BAR Meeting
June 19, 2013

ISSUE: Permit to Demolish/Capsulate and Addition/Alterations
APPLICANT: Andrew and Tamara Saltonstall by Patrick Camus
LOCATION: 217 South Fairfax Street
ZONE: RM / Residential

BAR2013-00169 & BAR2013-00170

SHOWING HOUSE LOCATION ON
 ON THE PROPERTY LOCATED AT
#217 SOUTH FAIRFAX STREET
 (INSTRUMENT #050003775)

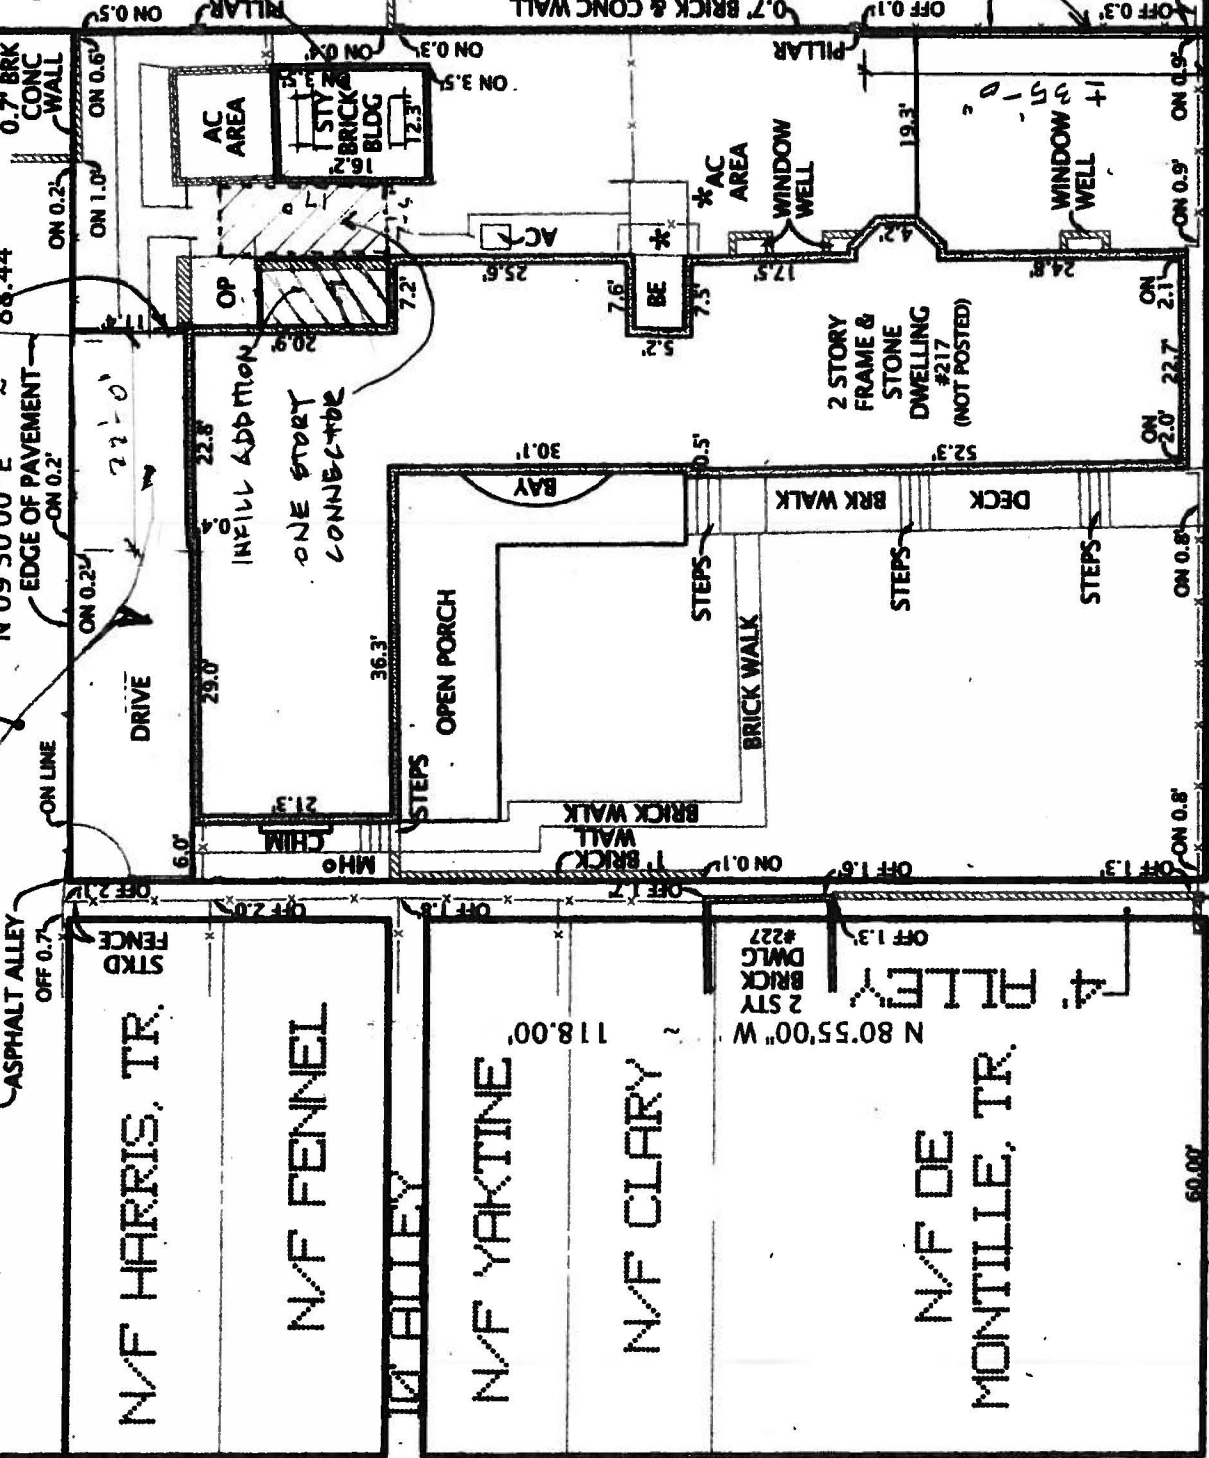
Staff supports the applicant's proposal to extend the 6' brick wall on the north property line an additional 35' to the front property line. In addition, Staff finds the relocation of the rear fence acceptable.

The increased height of the front property line fence is more problematic. As the BAR is aware, the Board has the ability to waive the front yard fence height "where the board finds that a proposed fence would be architecturally appropriate and consistent with the character of the district." Staff is somewhat reluctant to recommend approval of the height increase given that the public's ability to see and appreciate the open space was a representation made by a prior owner when requesting Board approval of the rear addition in 1992. In addition, the Board clearly articulated the historic solid/void relationship of buildings and open space on the west side of this block during the recent denial of a proposed garage at 207 South Fairfax Street. A tall, solid fence would diminish the rhythm of these open spaces on this block face. However, because the 50% open wood picket fence will remain atop the new brick retaining wall, Staff supports the minor height increase. Furthermore, the 6' fence will still be approximately one foot lower than the adjacent brick wall at 227 South Fairfax Street.

1 PARTIAL FIRST FLOOR PLAN - PROPOSED

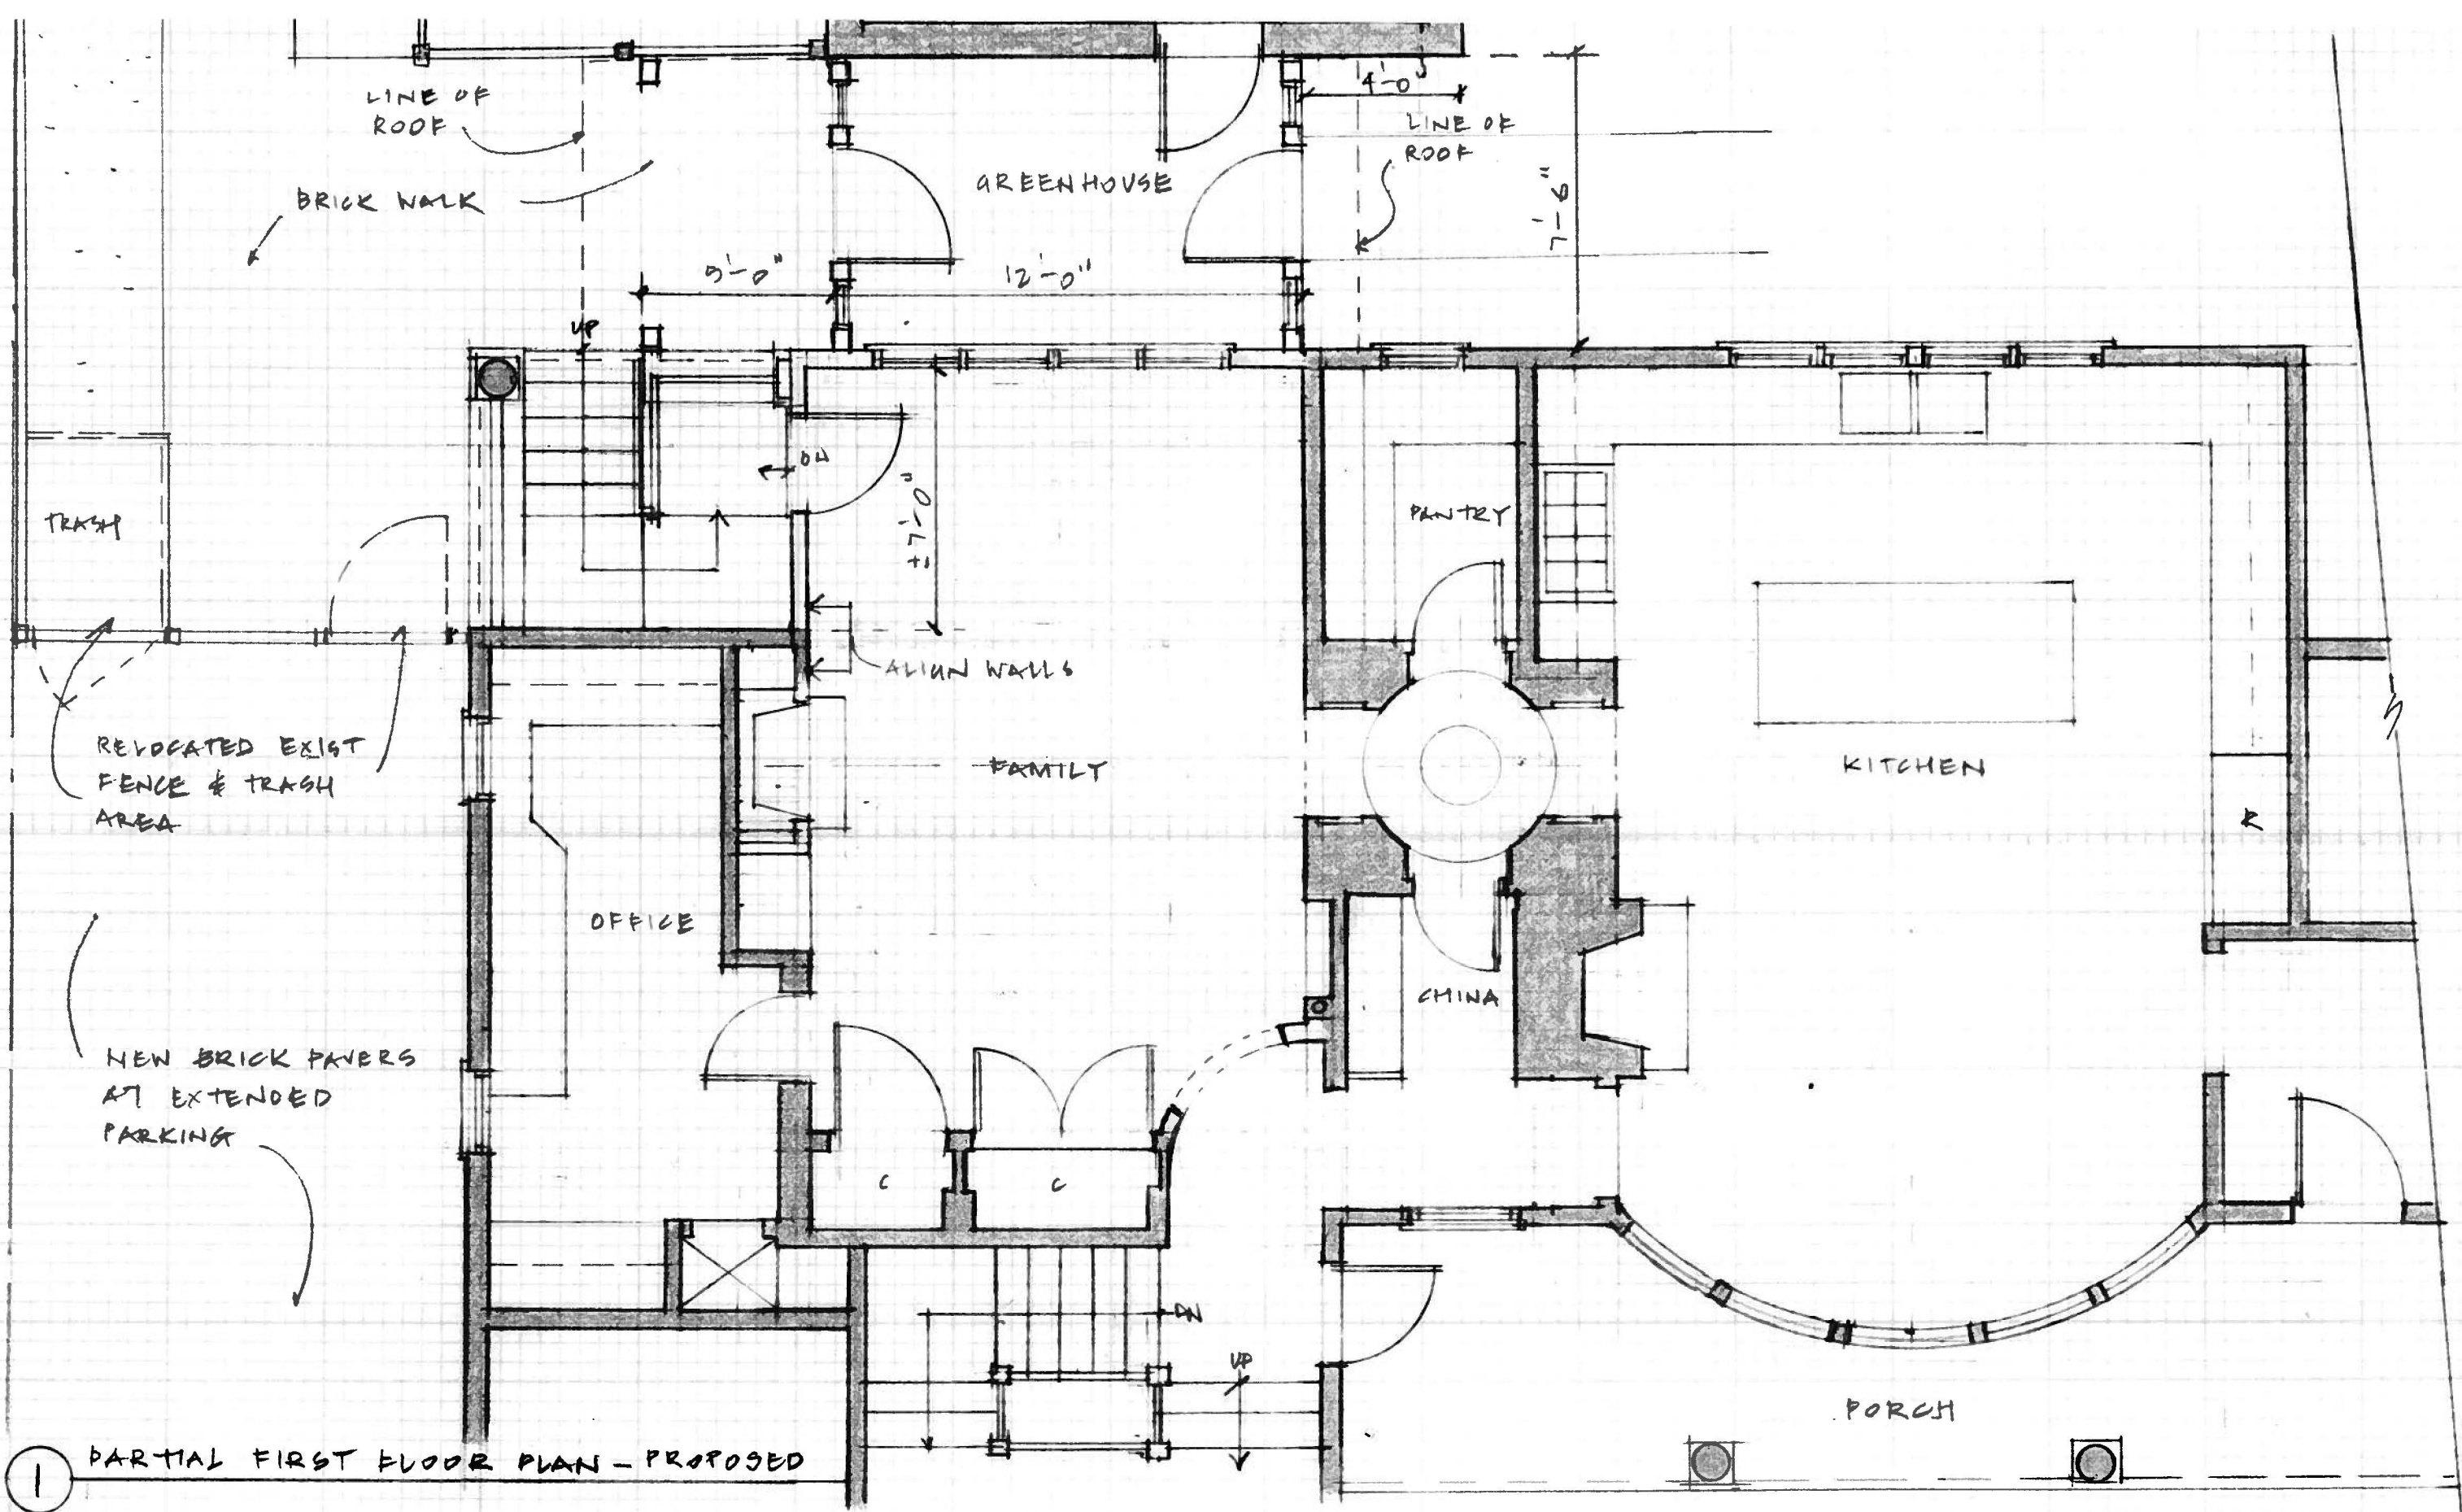
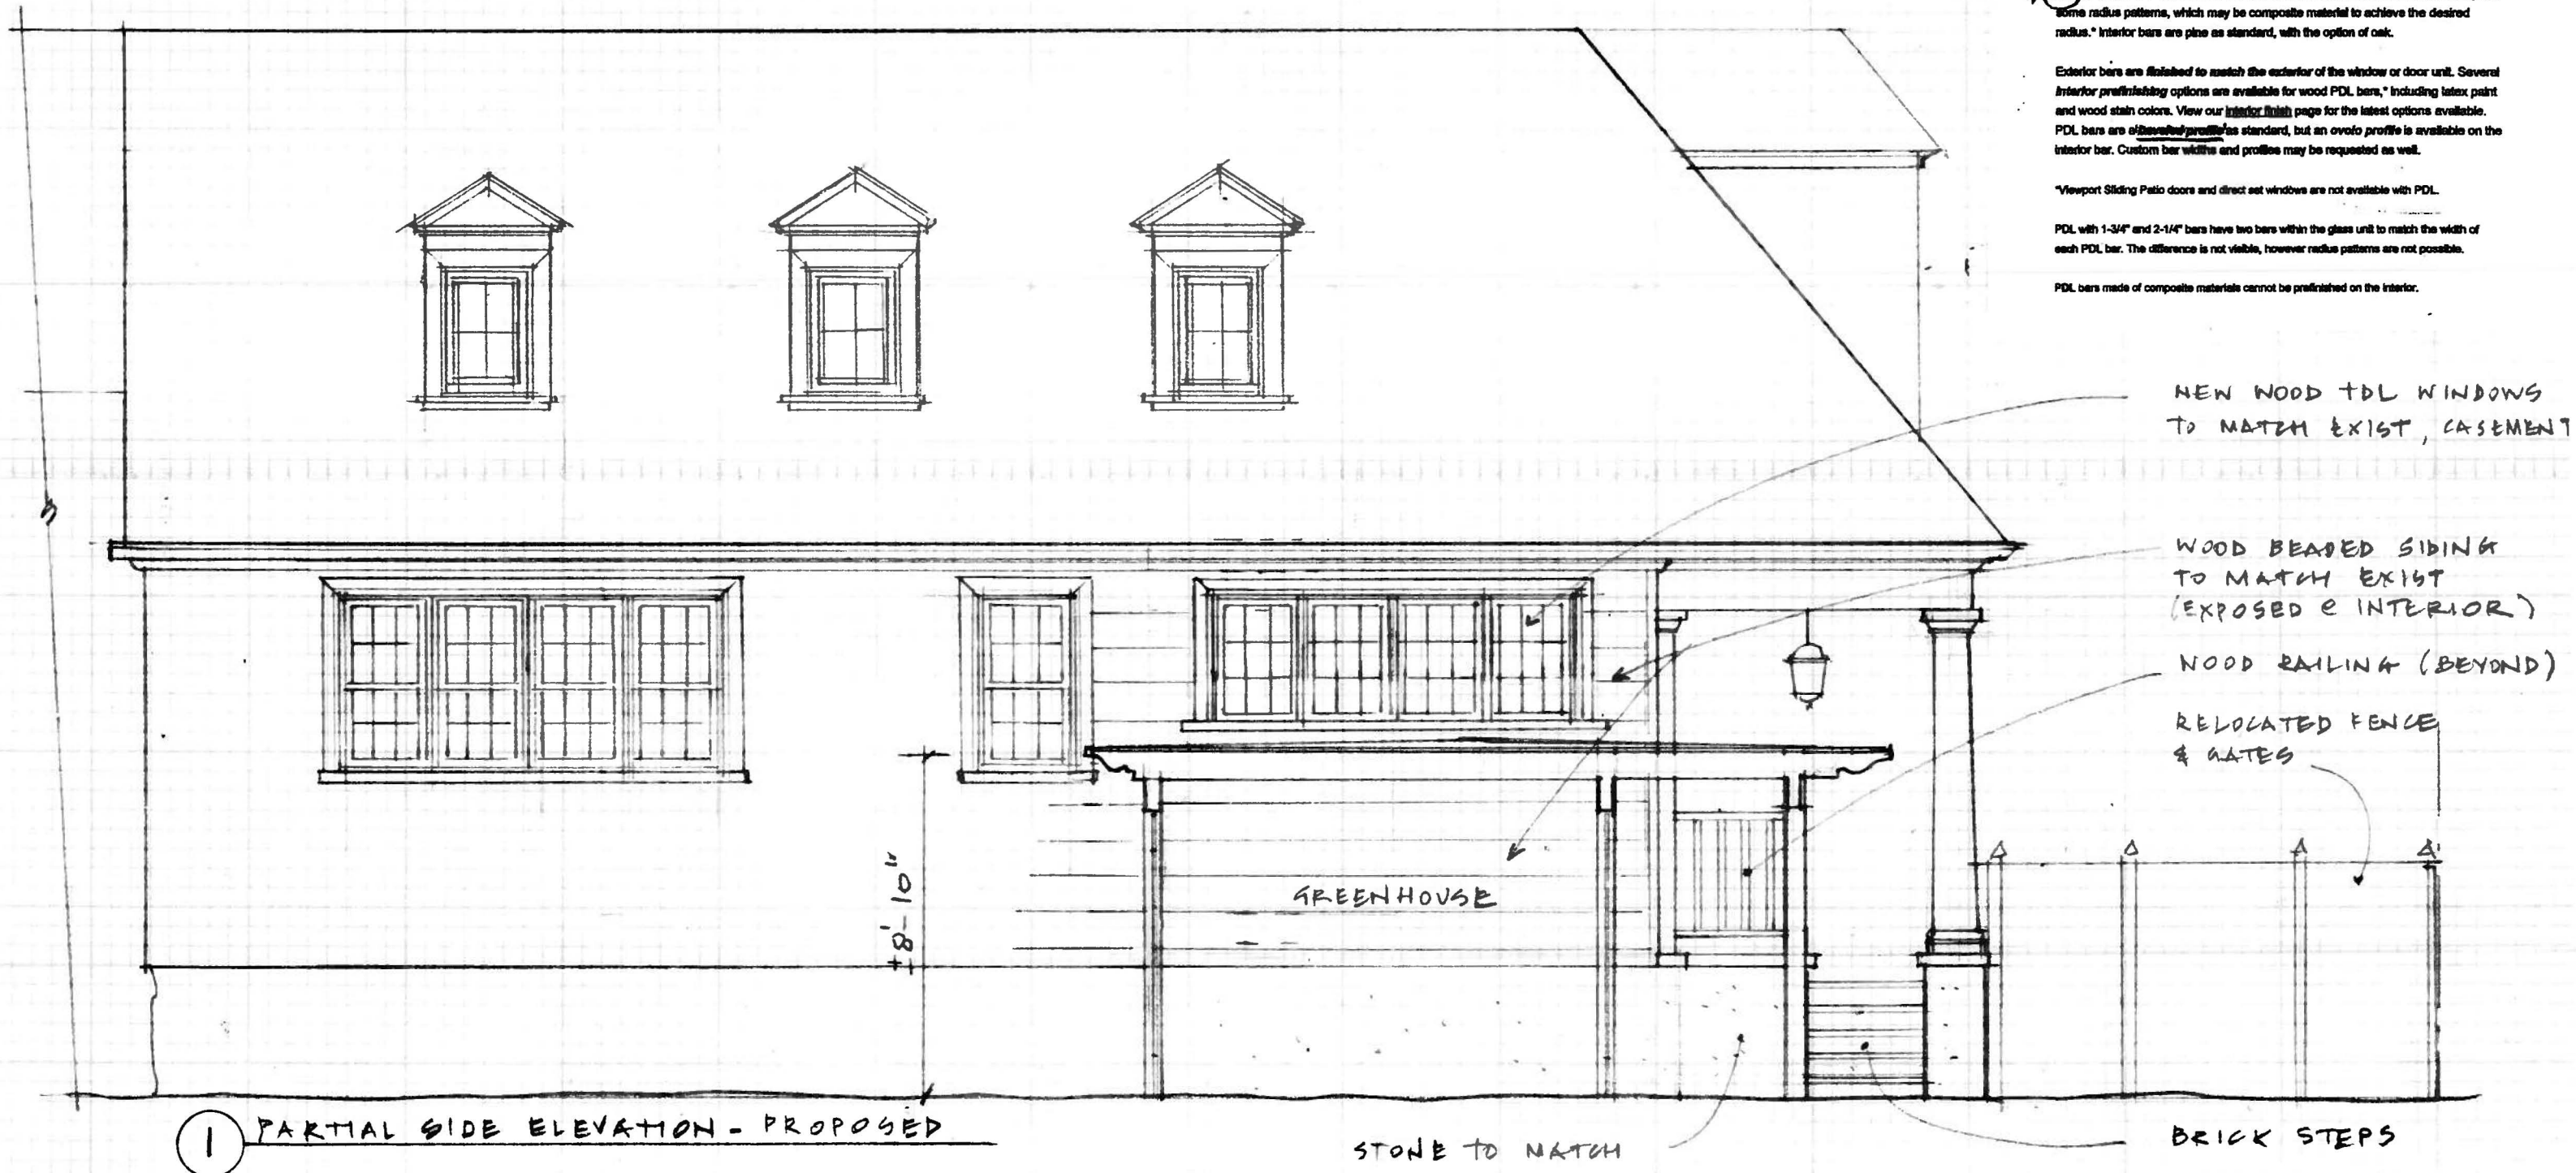
The *Design Guidelines* encourage “designs that are respectful of the existing structure and which seek to be background statements or which echo the design elements of the existing structure.” In the opinion of Staff, the small infill addition at the northwest corner of the house is compatible with the architecture of the historic building, as well as the later addition. The proposed materials are appropriate for the addition.

Staff is concerned about the at-grade one-story addition which will link the existing residence to the historic outbuilding. While the existing south wall will be capsulated and not demolished, the addition of this connector significantly compromises the historic integrity of the freestanding structure and further enlarges the footprint of this significant house. Outbuildings play a significant role in the history of Old Town, as they add a visible layer to the history of neighborhood development. Staff recommends denial of this portion of the application. Staff could support a simple trellis connecting the two features.

3. Denial of the at-grade infill addition between the house and the outbuilding; and
4. The following archaeology conditions shall appear in the General Notes of all site plans and on all site plan sheets that involve demolition or ground disturbance (including Basement/Foundation Plans, Demolition, Erosion and Sediment Control, Grading, Landscaping, Utilities, and Sheeting and Shoring) so that on-site contractors are aware of the requirements.
